STAFF REPORT

CASE 1: BZA-22-33 – PACHECO RESIDENCE – 4788 Jeannette Road

REQUEST: Review and approval of variance to Hilliard Code Section 1127.04(b)(1) to permit gravel as a driveway/parking surface within the rear yard of a single-family dwelling on 1.5 acres.

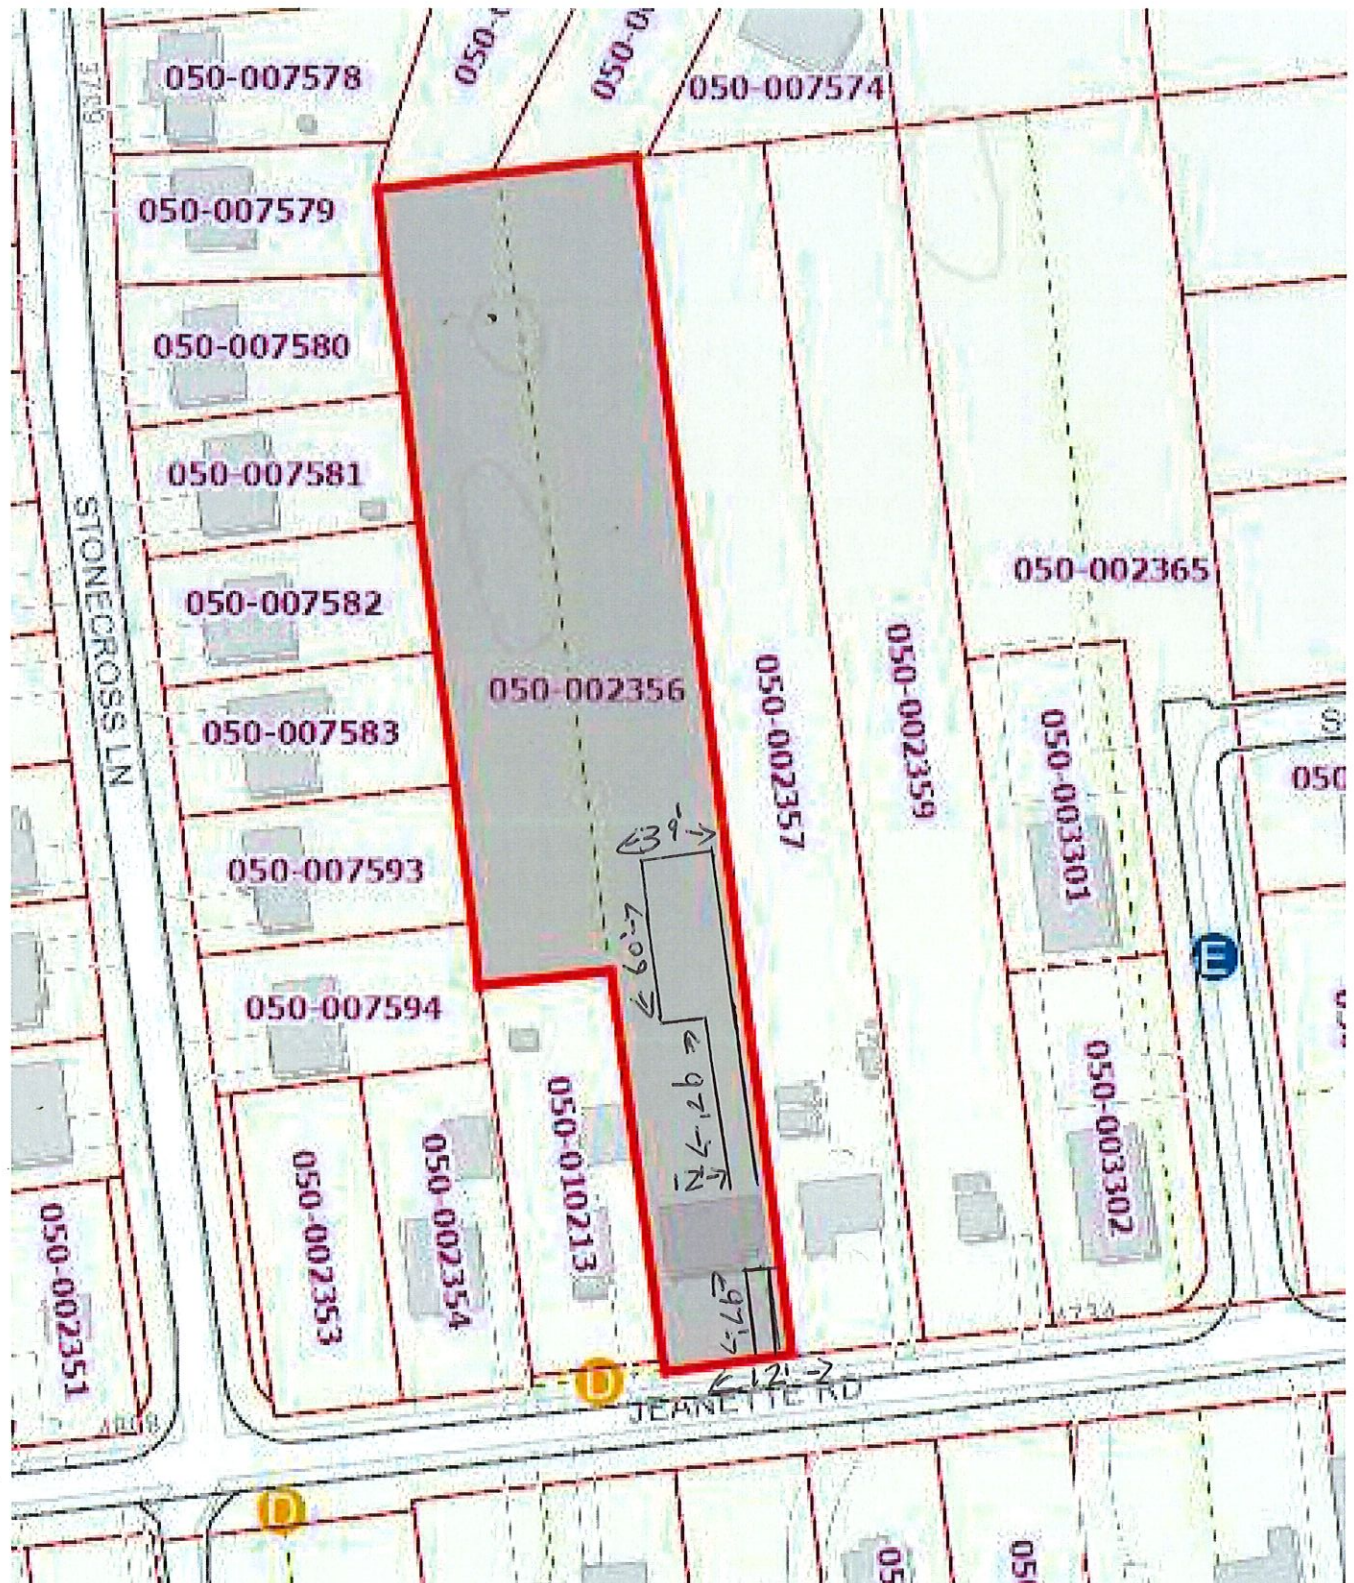
- The applicant has demolished the attached one-car garage and extended the existing driveway behind the residence. The 2,652 square feet of gravel includes a 26' x 12' driveway extension and a general parking area that is approximately 39' x 60' in size.

- Section 1127.04(b)(1) of the Zoning Code requires a paved surface of concrete or asphalt. The Code does not permit gravel parking areas. The Planning and Zoning Commission may approve alternative pavement systems such as pavers, brick or other permeable hard surfaces based upon the durability and appearance of proposed materials for parking areas, but the proposed gravel would not meet the general parameters for Planning Commission consideration.

- In the recent past, a variance has been granted for a gravel driveway providing access to an accessory structure off Dublin Road. In that case, the gravel would be rarely used to access an accessory garage at the rear of the lot, and the property owner had a significant paved driveway that would restrict the disbursement of gravel toward the public street. Two requests for gravel parking expansions for commercial properties have been denied by the Board within the last year.

Staff finds that the proposed variance to Section 1127.04(b)(1) for the purpose of expanding gravel parking area behind a home within a residential district is not appropriate and would set a negative precedent for other properties throughout the city. Staff finds that the expanded gravel is visually significant and will have a negative impact on surrounding properties and the general area. There can also be beneficial use of the property without the variance and that the proposal would be a substantial departure from the Code. Staff finds that the proposed variance does not meet the spirit and intent of the Code and the provisions listed within Section 1106.04 of the Code. Based on these findings, staff respectfully recommends that the variance request be denied.
